Tyler Grange Comments 15.07.2020

Application No: V/20/87717

Address: Land West of, Horton Heath

Landscape Officer Comments 15/05/20

Project	West Horton Heath, Eastleigh
Drawing Title	Figure 14.6: Landscape Character - Eastleigh LCA
Scale	As Shown (Approximate)
Drawing No.	11705/P09a
Date	June 2020
Checked	KL/RP

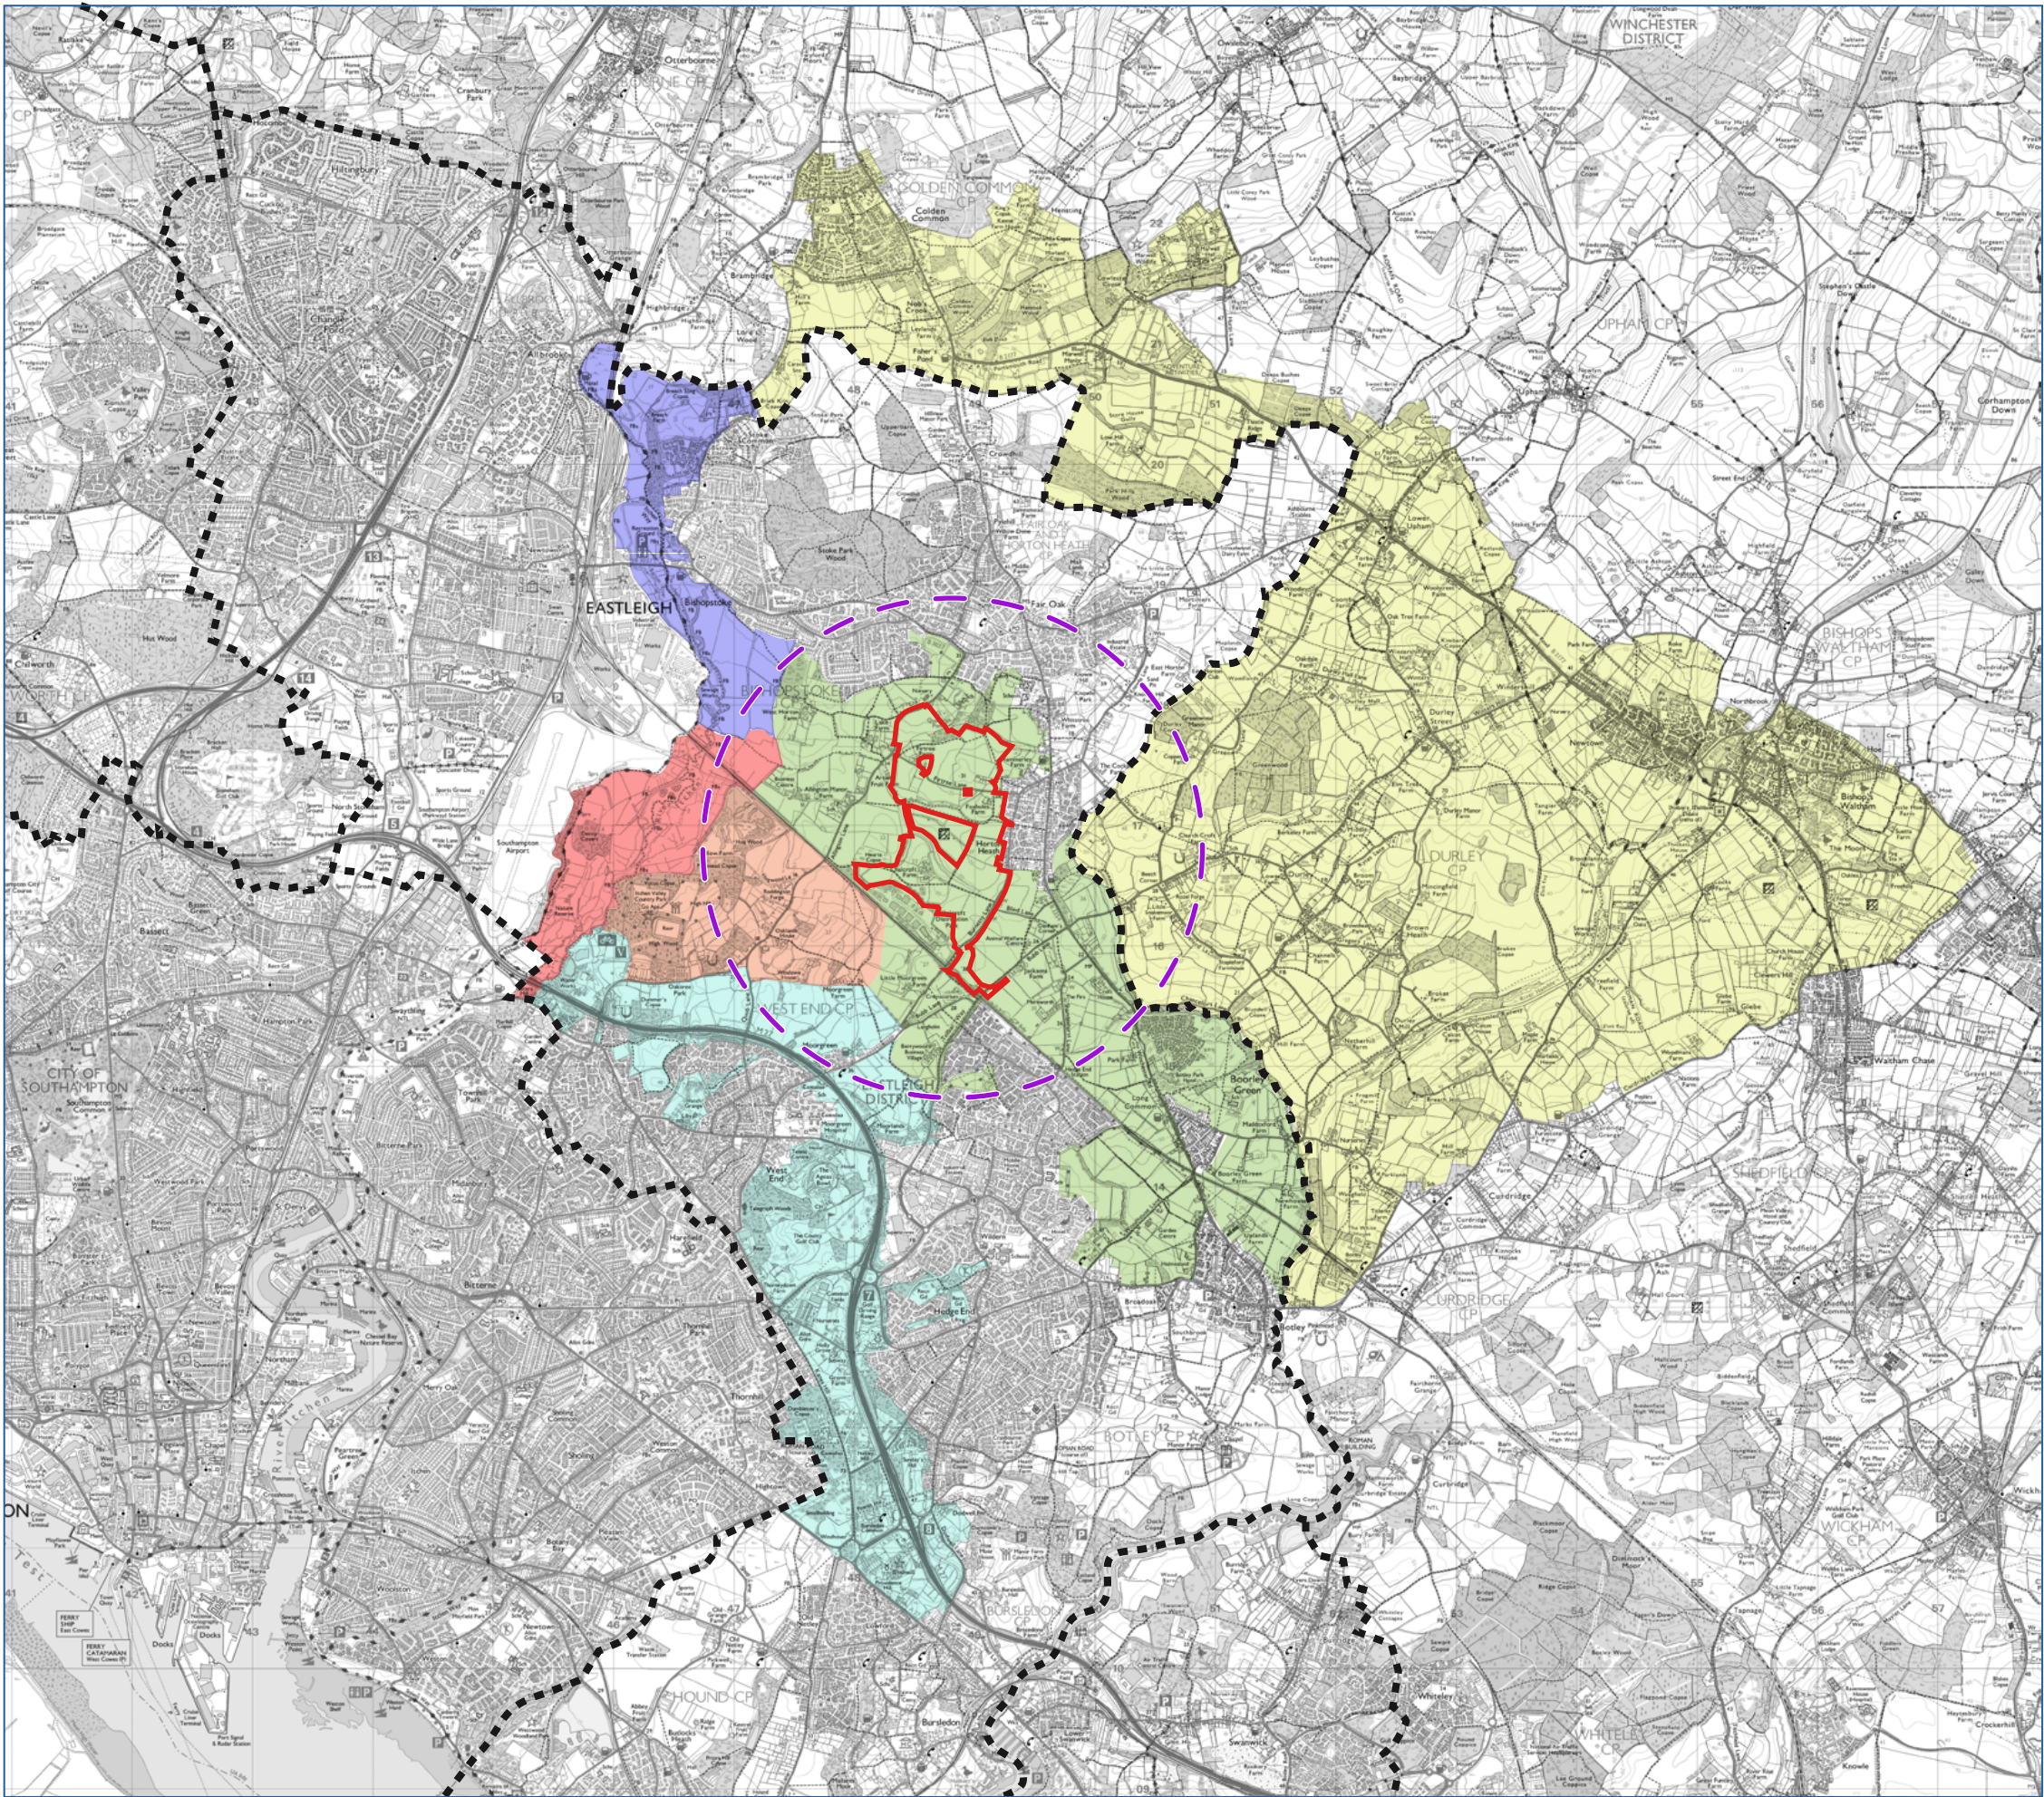
b) The ZTV and viewpoints plan Appendix 14.2 shows the Study Area as a circular dashed line. Both the descriptive text in the Scoping Report and the Plan indicate that the Study Area (Geographical Scope) has been decided purely on the Visual Envelope.

In LVIA it would be common for the Visual Envelope to be smaller the Study Area as a whole. This is because the LVIA is assessing both Landscape and Visual Impact. Effects upon a Landscape as a resource needs to be considered at the appropriate scale for that specific resource, which may exceed the Visual Envelope. It also needs to consider potential impacts on adjoining Landscape Character Areas, even if these are scoped out at an early stage.

Action: Please address this in the Scoping Report and adjust the Study Area accordingly. Please plot the Study Area on a plan which also shows the Borough scale Landscape Character Areas and include this in the Appendix with the other plans.

In this instance, it is considered that a combination of both the ZTV and Landscape Character Areas is appropriate. The LVIA will consider the borough character areas and whether those beyond the site area are likely to be significantly affected when scoping the assessment in light of the strategic masterplanning of the proposals and potential landscape effects.

To ensure that the LVIA considers the published borough landscape character areas (LCA), the Study Area will be increased to include those character areas adjacent to the site and land within the ZTV. This will also capture the extent of the ZTV and Proposed Photoviewpoints. **[See Figure 14.6 attached]**

The Study Area will also be illustrated on a separate plan that shows the Area in relation to the full extent of the adjacent LCAs as defined in the Eastleigh Borough Landscape Character Assessment, namely:

- Horton Heath Undulating Farmland (within which the site lies);
- Knowle Hill Farmland and Woodland(to the east)
- Upper Itchen Valley (to the northwest
- Lower Itchen Valley Floodplain (to the west);
- Oaklands Woodland and Parkland (to the southwest); and
- M27 Corridor (to the south)

Project	West Horton Heath, Eastleigh
Drawing Title	Appendix 14.2: Proposed Photoviewpoint Locations and Additional Local Authority Locations
Scale	As Shown (Approximate)
Drawing No.	11705/P05a
Date	April 2020
Checked	RH/JS

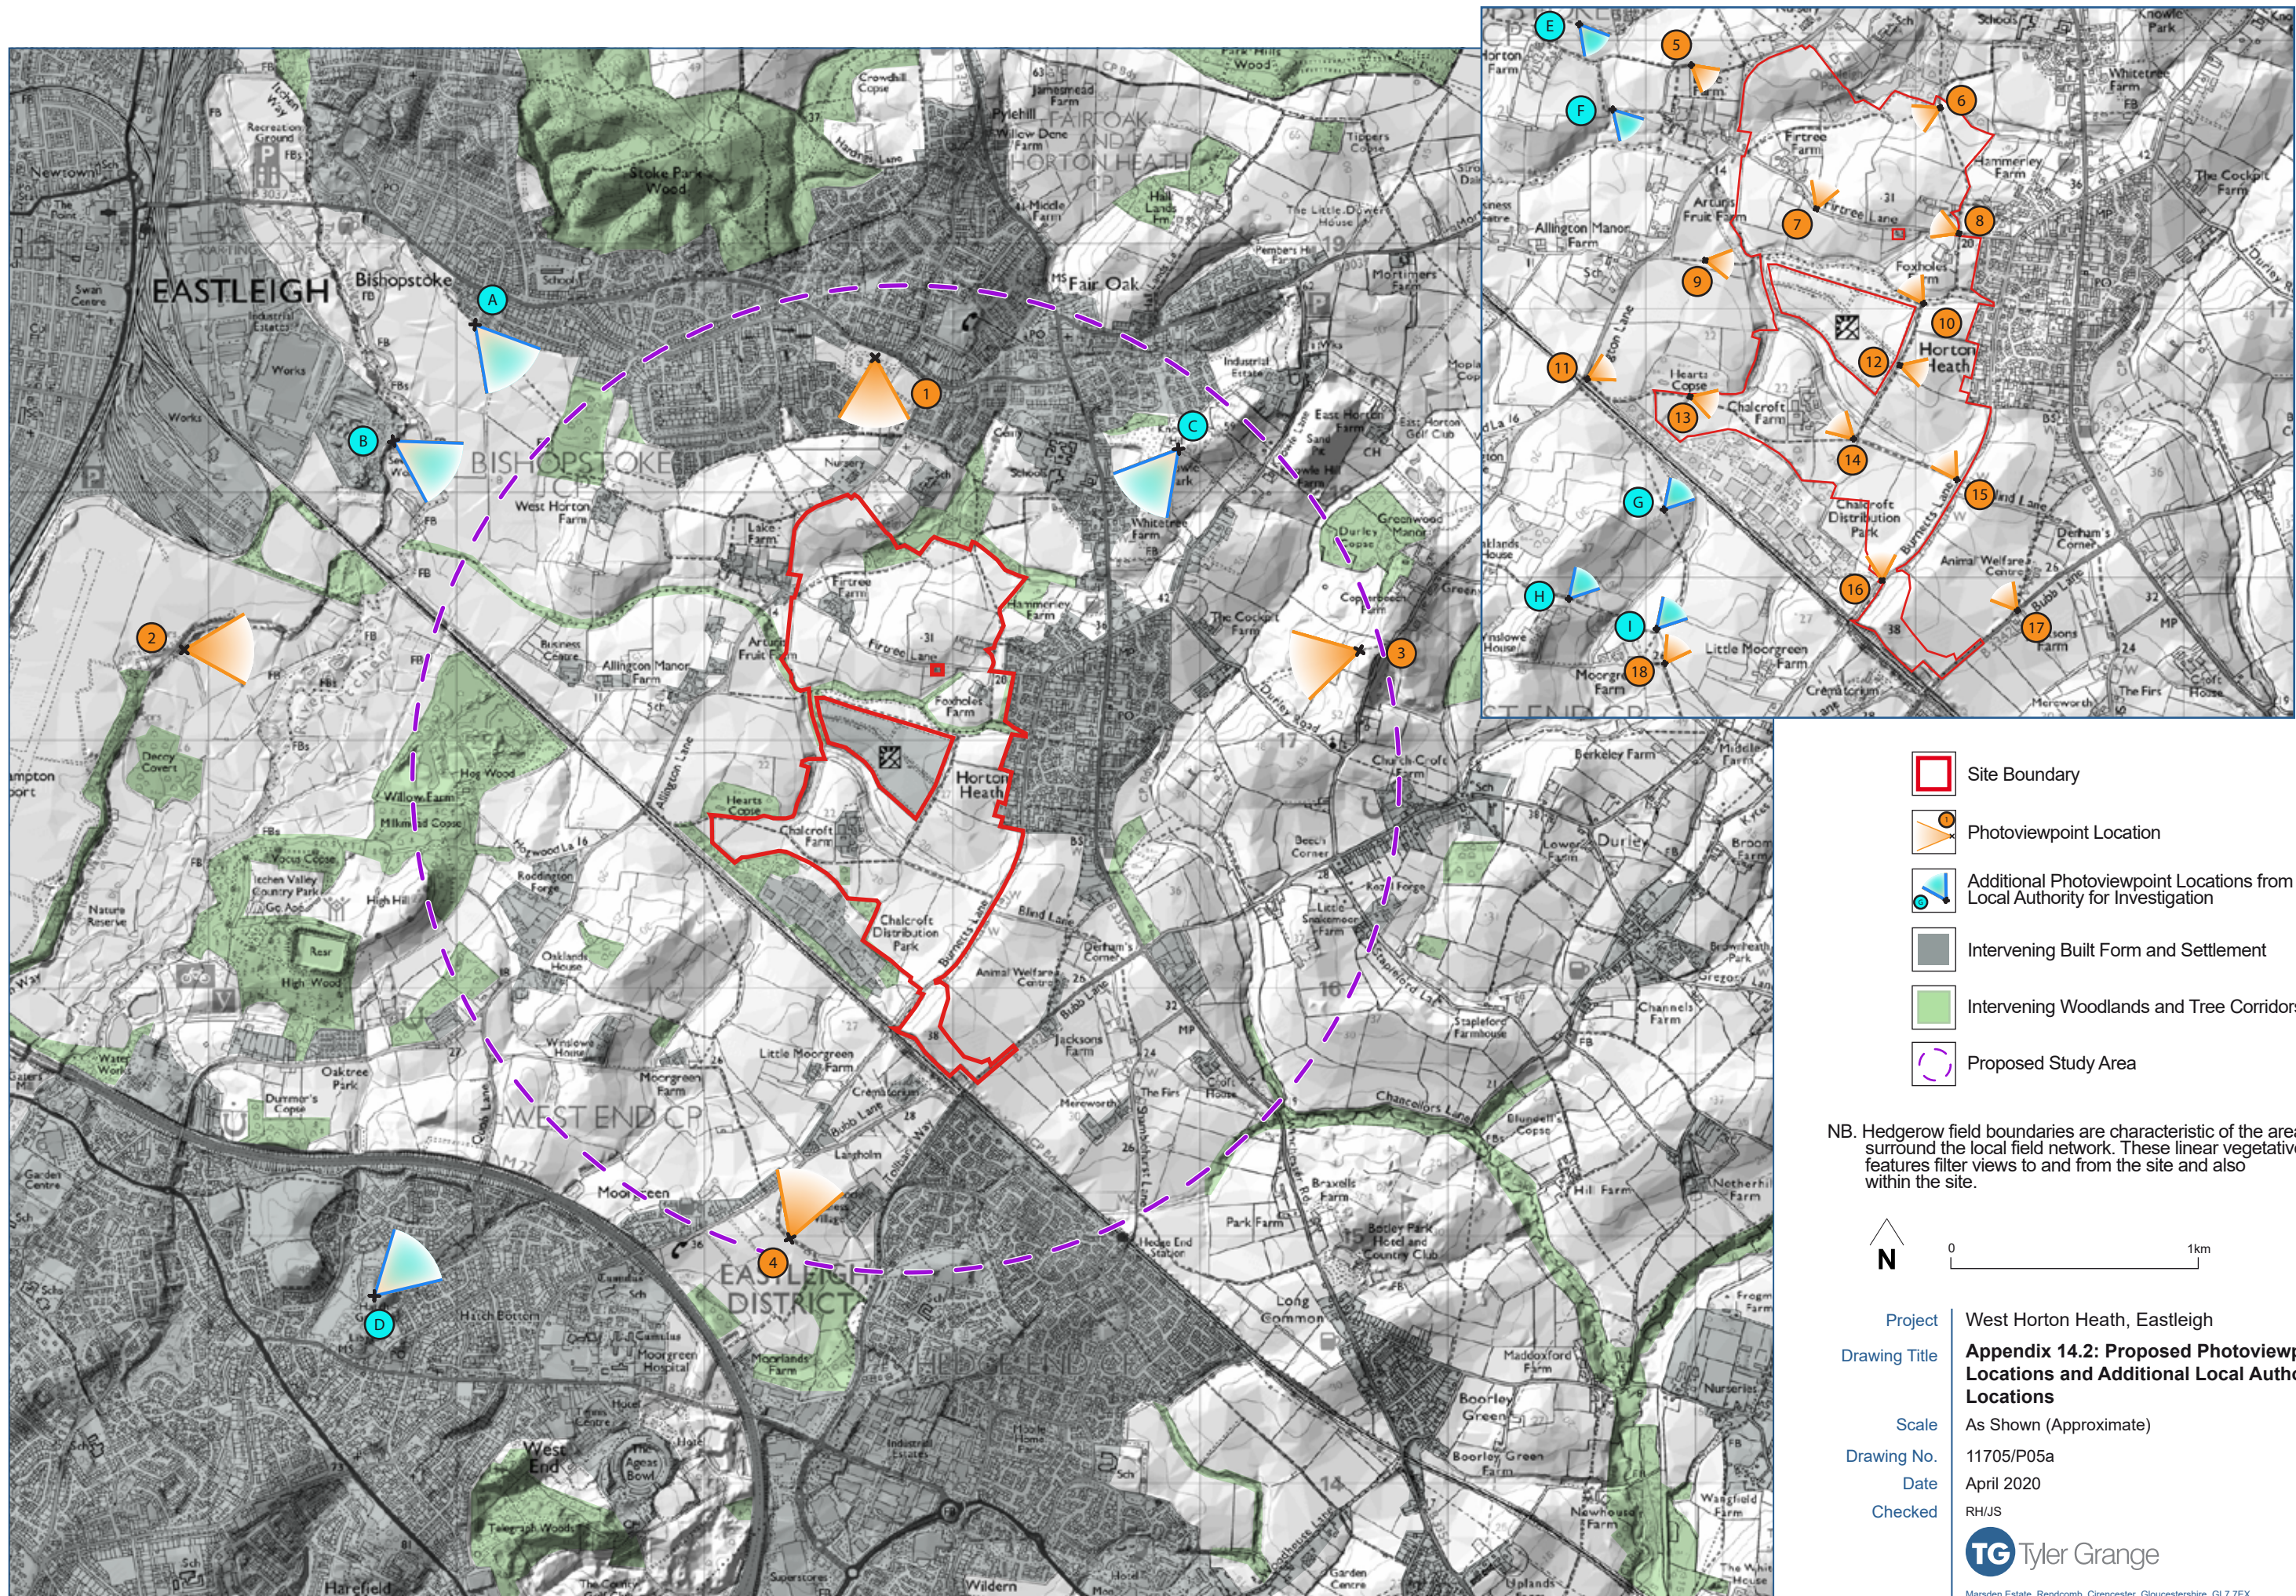
a) If fieldwork has shown the Visual Envelope is less extensive than suggested on the ZTV then I would expect to see representative photographic viewpoints to demonstrate this, and for these to be included in the Scoping report Appendix. Please could this be addressed?

The Representative photoviewpoints included on the "Proposed Viewpoint Locations and Additional Local Authority Locations" drawing at Appendix 14.2 have been included to demonstrate the extent of visibility of the site from areas within the ZTV. These include additional views requested by the LPA through previous scoping.

Some of the more distant viewpoints on the lower-lying land to the northwest (photoviewpoint 2 and additional viewpoints A and B) and from within Hatch Grange, West End (additional viewpoint D) demonstrate that the site area is NOT visible. These are situated outside the proposed Study Area.

The Photoviewpoints will be annotated to demonstrate those from which the site is visible, as well as those that fall beyond the visual envelope, and are within the ZTV.
